FPL Energy
Seabrook Station

Seabrook Station
Facility Operating License NPF-86
Response to Request for Additional Information Regarding
License Amendment Request 05-08
"Limited Inspection of the Steam Generator Tube Portion within the Tubesheet"

**License Amendment Request 05-08
Limited Inspection of the Steam Generator Tube Portion within the Tubesheet
Response to NRC Requests for Additional Information**

Figure 1: Sketch of Cracked Tube in Tubesheet Leading to Leakage Flow-rate, Q_{OUT} .
Note that the gap shown between the tube and the tubesheet is for illustration purposes only.

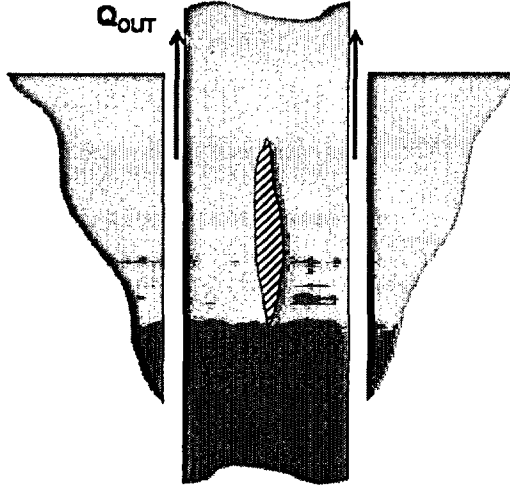
Under the proposed 17-inch tubesheet inspection zone, LAR 05-08 contends that the accident leakage integrity of the tubing below the 17-inch inspection zone is ensured by the bell-weather principle. The NRC staff requests that the licensee submit a leakage sensitivity study to support the conservatism of the bell-weather approach. That is, leakage during accidents will not exceed two times that observed during normal operating conditions. It is requested that this study consider axial and circumferential flaws located at the bottom of the tubesheet at three tubesheet radial locations (i.e., at the zero radius, mid-radius, and peripheral locations). For each crack type at each location, leakage under normal operating and accident conditions should be evaluated considering only the crack leakage resistance, considering only the tube-to-tubesheet annual resistance and, lastly, considering the total resistance of the crack and annulus to leakage. Please note that the staff is not so much interested in the absolute values of the leakage predictions as it is in the relative values of the predictions between normal operating and accident conditions. As LAR 05-08 has not requested that the staff review the leakage prediction models, the NRC staff would not be in a position to approve these models until the accuracy of these models has been validated by test for prototypic situations. Notwithstanding that, the NRC staff believes that these models, which are based on standard engineering principles, should at least be capable of providing a qualitative demonstration supporting the bell-weather approach.

The new model for the axial crack opening that takes into account the guidance and constraint provided by the surrounding tubesheet is described in what follows. See Figure 1 below for a sketch of the model configuration.

Using these models, a sensitivity study was performed which consisted of a series of analyses to demonstrate the conservatism of the bellwether approach. These analyses considered the locations and conditions specified in the RAI, i.e., crack only, crevice only and combined crack and crevice.

Figure 5: SLB Design Pressure Change History

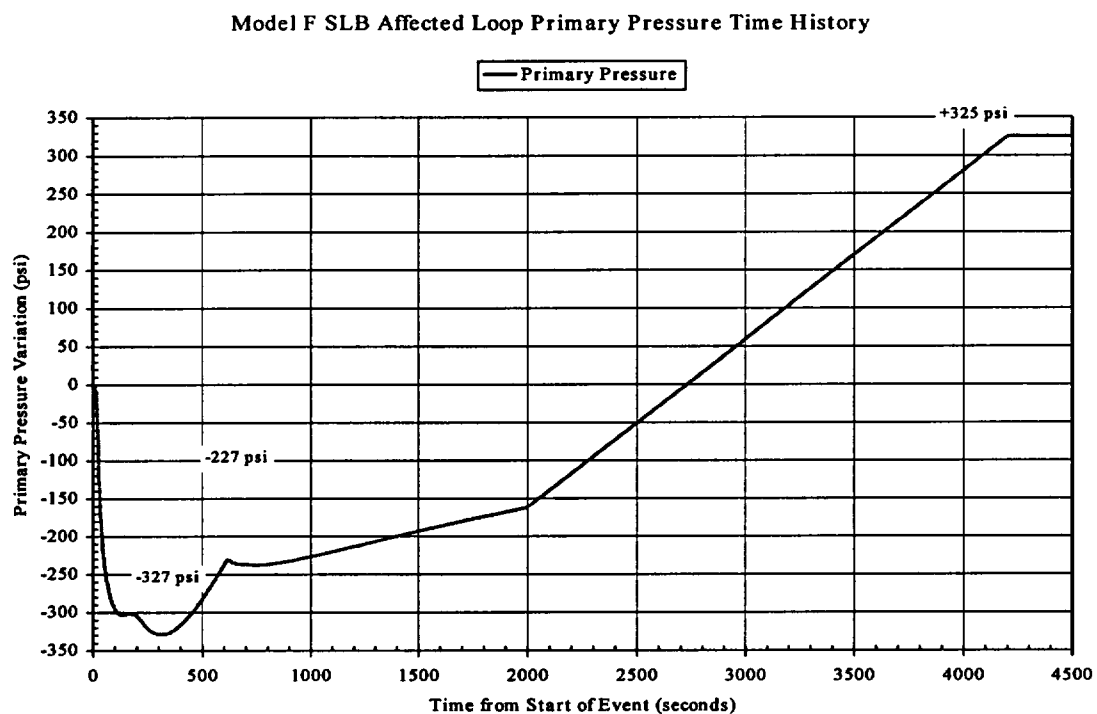
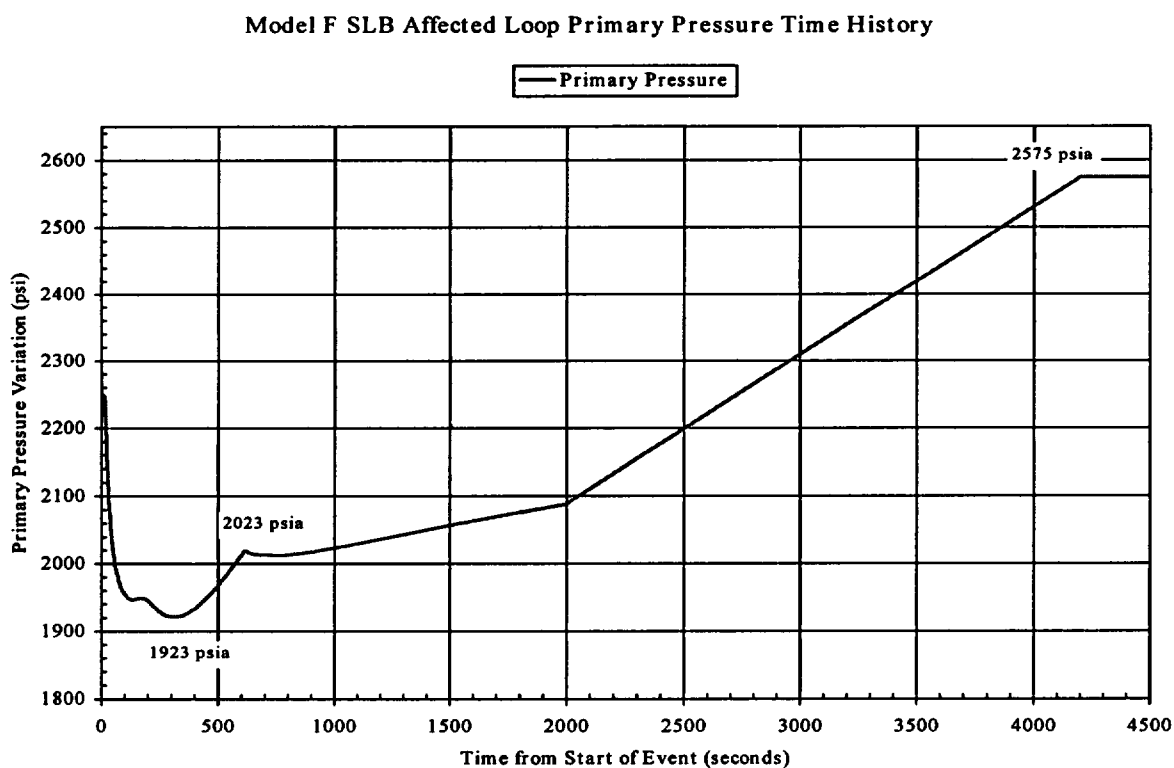
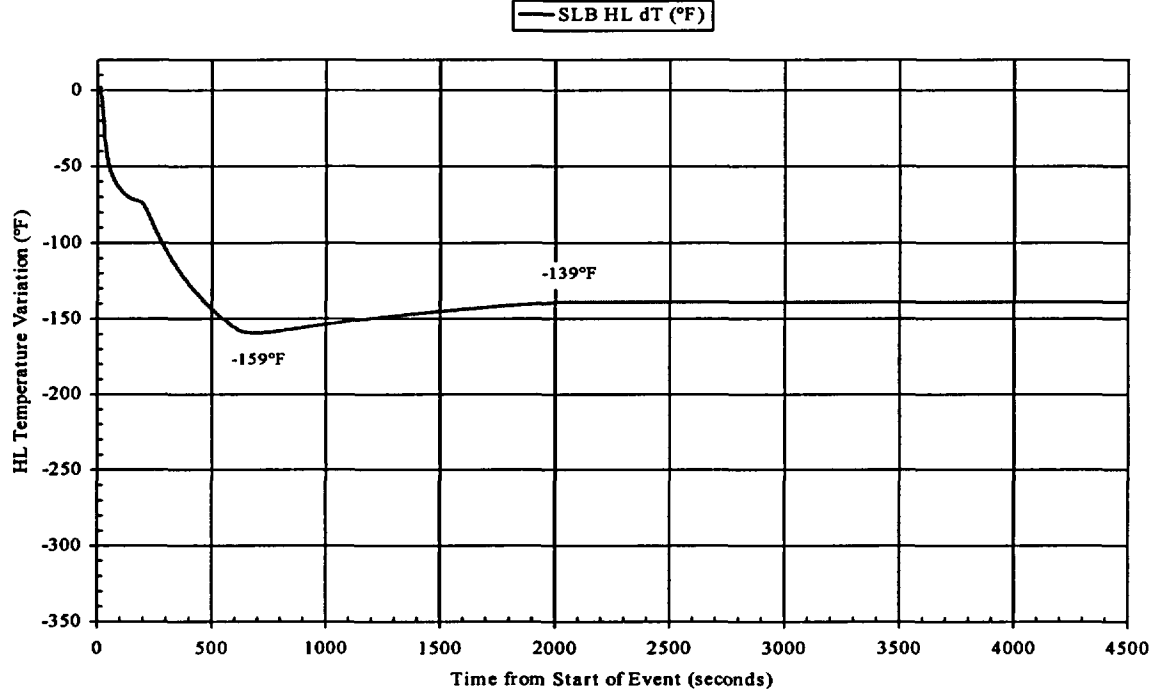
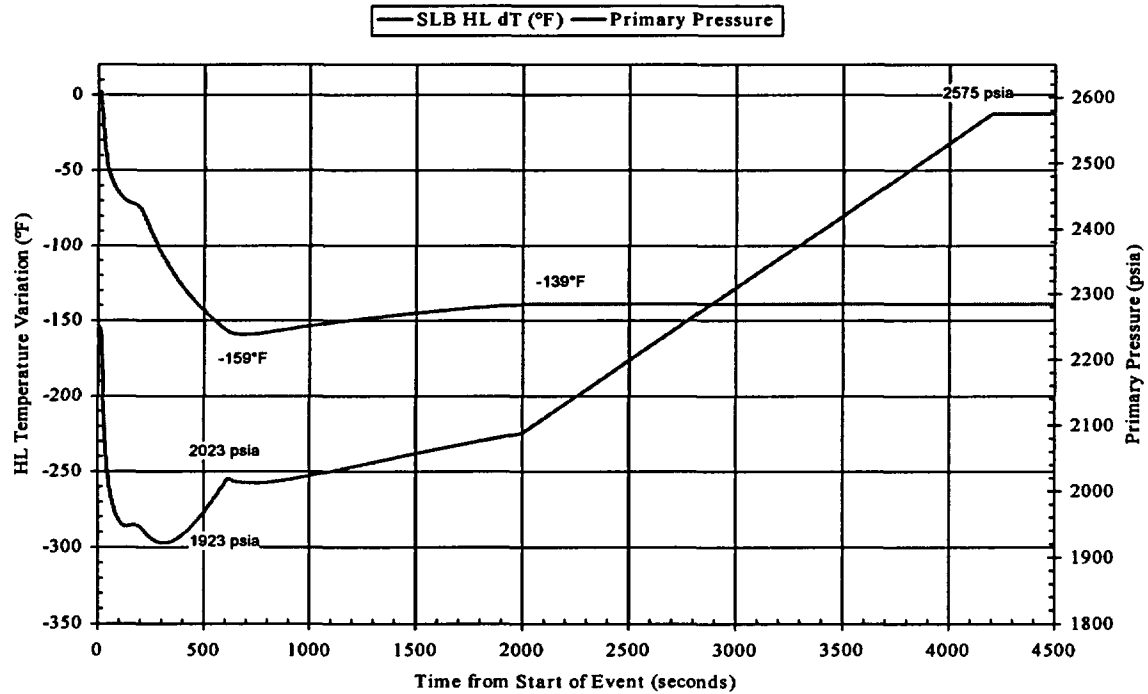
The bell-weather principle maintains that the increase in primary-to-secondary leakage, when going from normal operating to accident conditions, is bounded by a factor of two. This is based, in part, on an assumed main steamline break (MSLB) and main feed line break (MFLB) pressure differential of 2560 and 2650 psi, respectively, and a temperature of 600 degrees F. Provide the rationale which supports the conservatism of the 600-degree F assumption. This rationale should consider the time history of primary and secondary pressure and temperature during the accident. The NRC staff's purpose in asking this question is to ensure the time integrated leak rate is bounded by the bell-weather principle factor of two increase relative to normal operating leakage. Provide the primary pressure and temperature curves as a function of time for the MSLB and MFLB accidents under consideration. Also, provide the rationale supporting the conservatism of the bell-weather principle for a large break loss-of-coolant accident.

The calculation of the leak rate during a postulated SLB event is not based on a temperature of 600°F, but on the temperature obtained from an examination of the equipment specification curves for the transient. In addition, the calculation of conditions during normal operation is based on a set of umbrella values resulting in considering primary fluid temperatures of 604.3 and 621.4°F for secondary side pressures of 782 and 947 psig respectively. Both conditions are used.

The SLB transient is assumed to initiate while the plant is at hot standby conditions, i.e., 557°F. The primary temperature drop is 139°F leading to an analysis temperature of 418°F. The secondary temperature drop is 307°F leading to a shell temperature of 260° for the analysis. The design specification pressure changes are illustrated on Figure 5 and the actual pressures for Seabrook are shown on Figure 6. The design specification temperature history during a postulated SLB event is shown on Figure 7. The superposed curves are shown on Figure 8. It is readily seen that the most limiting differential pressure, 2575 psi, occurs when the temperature is at a relatively steady state for both the hot and cold legs. The analyses were performed for the conditions at about 600 seconds into the transient and found to be less limiting than when the pressure difference is at a maximum. The H* engagement length required to resist the SLB differential pressure with a margin of 1.4 is about 0.15 inch greater for the latter condition. The B* length to restrict the SLB leak rate to a factor of 2 relative to that during NOp, based on the method of calculation, is about 7% longer for the conditions at 4200 seconds relative to those at 600 seconds. Examination of Figure 8 leads to the conclusion that the differential pressure is the controlling factor and the value at 4200 seconds will bound any value in between the two.
